XtremeAir GmbH, Harzstr.2, D-39444 Hecklingen Tel: +49 39267 60999 0, Fax: +49 39267 60999 20 www.xtremeair.de info@xtremeair.de	Document No. SB-XA42-2018-017
		Issue: A.00
DOA-Nr.: EASA.21J.360	Service Bulletin	Date: 03.08.2018

Subject:	Front baffling improvement
Aircraft type affected:	XA42
Serial numbers affected:	MSN 132 and 137 – 151
Compliance:	At user discretion
Time of Compliance:	During the next scheduled maintenance
Purpose:	To notify the owner of the subject aircraft of an improvement of the LH front baffling.
Background:	A narrow gap between the LH front baffling and the lower cowling leads to rubbing and wearing of the baffle seal. Damage of the lower cowling could occur.
Manpower:	It is estimated that three (3) man-hours are necessary to apply this service bulletin.
Materials:	The following materials are necessary: (6) ea. Aluminum pop rivet DIN7337-A-4x8 – or equivalent – Consumables: - Silicone baffle seal 1/8" x 2"
Accomplishment Instructions:	Read all the instructions and make sure the complete procedure is understood before starting the assembly work on the aircraft. In case of doubt, contact the manufacturer. <ol style="list-style-type: none"> 1. Remove the low

Figure 3: Marking of the 6 hole positions for the pop rivets

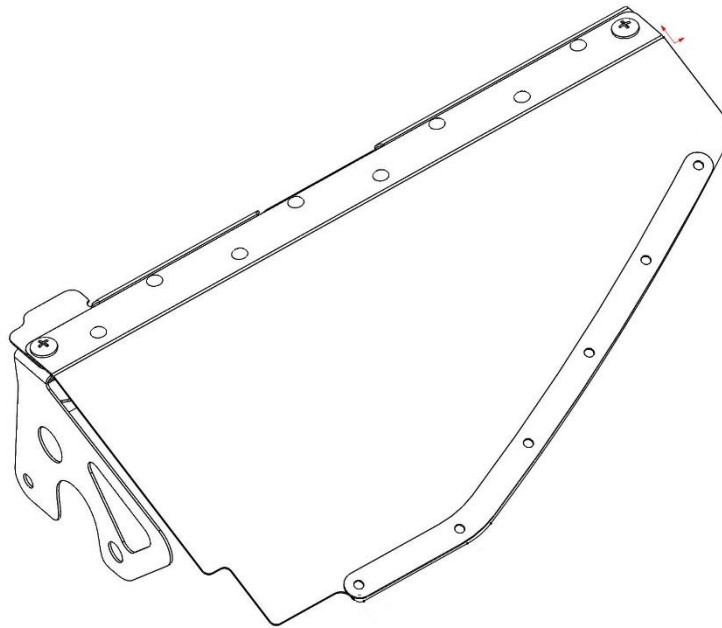
7. Drill dia. 4,1mm holes at the marked positions.
8. Flange the front edge of the baffle similar to the previous edge. Refer to Figure 4 for approximate flanging dimensions.
9. Cut out a baffle seal using the old one as a template.
10. Attach the baffle seal with the reinforcement strap to the front baffle using the DIN7337 – A – 4x8 pop rivets.
11. Reassemble all items in the reverse order.
